3.0 + Dwelling Information

Block A - GA Plans - Drawing No. 0203

Approved NMA Drawing (Ref:220434)

NMA Site wide Amendments - to be approved
01	Levels amended to east-west route through the landscape area, resulting in changes to the levels of the play mounds adjacent and omission of the retaining walls proposed previously adjacent to the path.
02	Additional refuse collection bay included adjacent to the new apartment refuse store and landscaping amended accordingly.
03	Riversley Court proposed refuse bay extended by 3.7m into the central green space.
04	Tree to the south of 203 Irving Court on the Wensley Road junction, relocated to a larger tree pit in the north-west corner of the new 203 parking court. Tree to east of 203 Irving Court relocated to a larger tree pit in the north-east corner of the new 203 parking court.
05	To provide sufficient space for the Wensley Hub, 5 proposed trees to be relocated offsite - located within the Coley Ward.
06	Relocation of 9 proposed trees adjacent to C1 and C2 and planting changed from herbaceous to grass in this area.

Block C2 West Elevation - Approved NMA Drawing (Ref:220434)

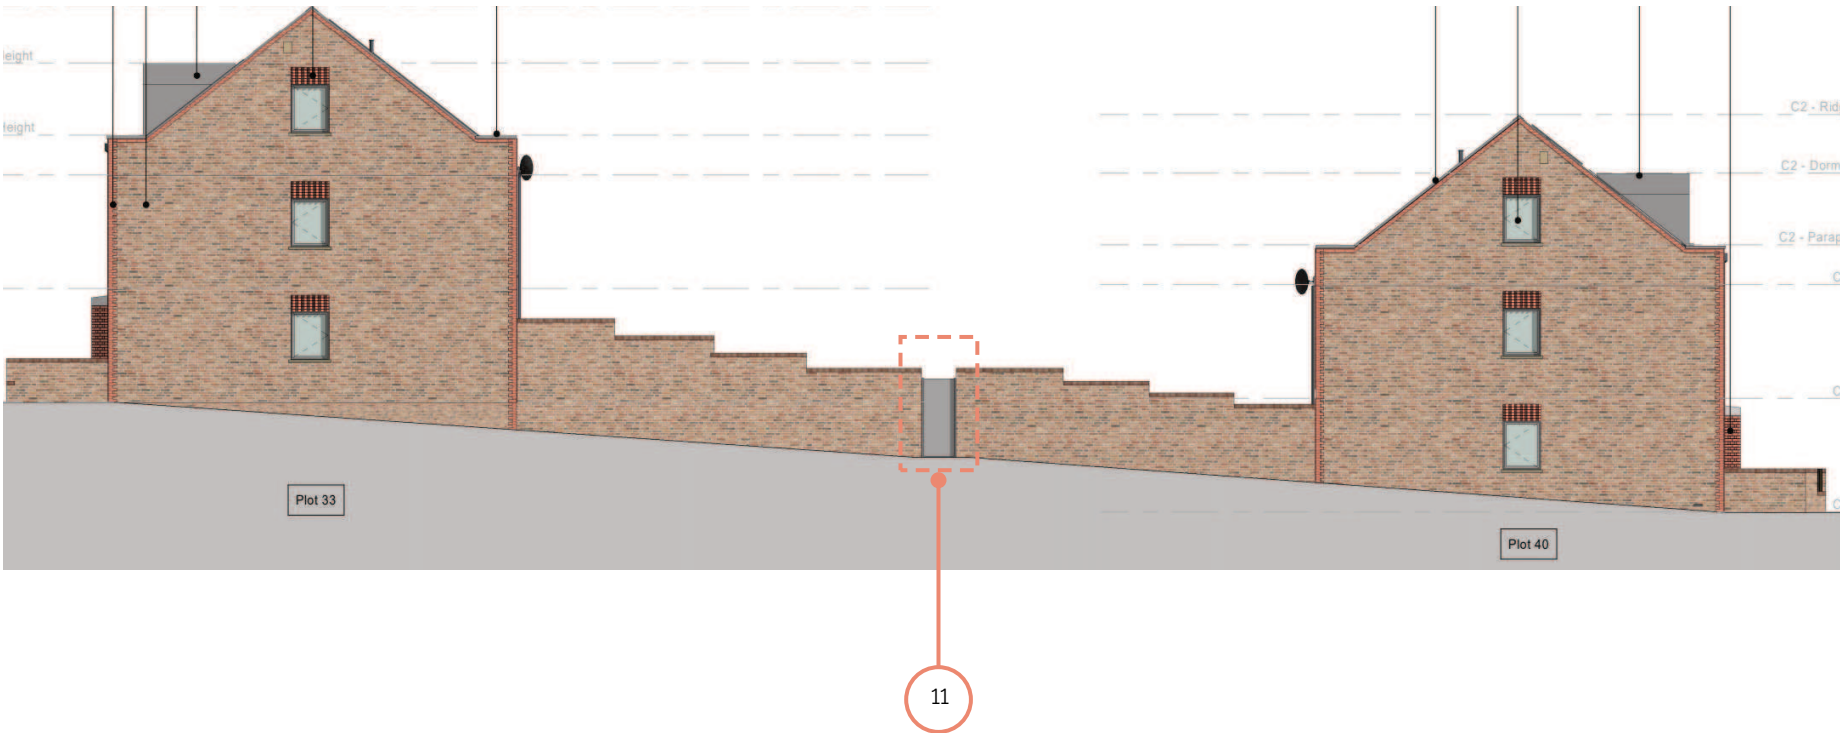
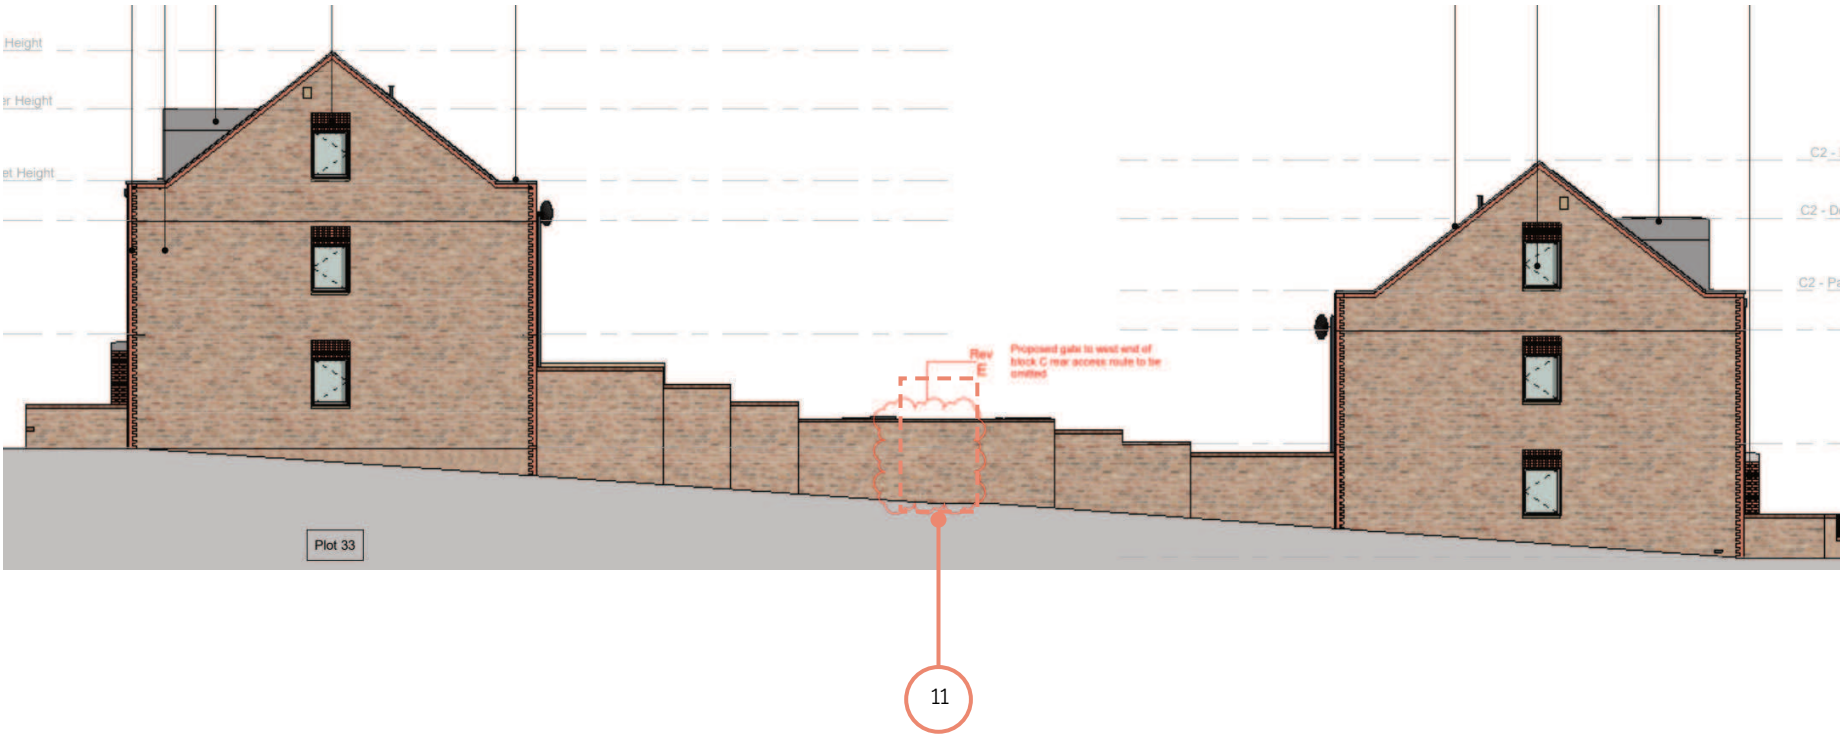
D	Areas of impermeable paving changed to permeable.
E	Tree species types amended
F	Material to perimeter of central green space changed to match general pavements.
	Dwelling Amendments - to be approved
DW1	Overall number of PV panels to remain the same. Number of PV panels on each of the seven houses in the C2 terrace increased by 3 provided by omitting 1 panel from the other 21 houses.
DW2	Block B2 Stair rooflight increased from 1910mm to 2500mm
DW3	Reposition of stair windows to rear of Block B2, with removal of central window recess
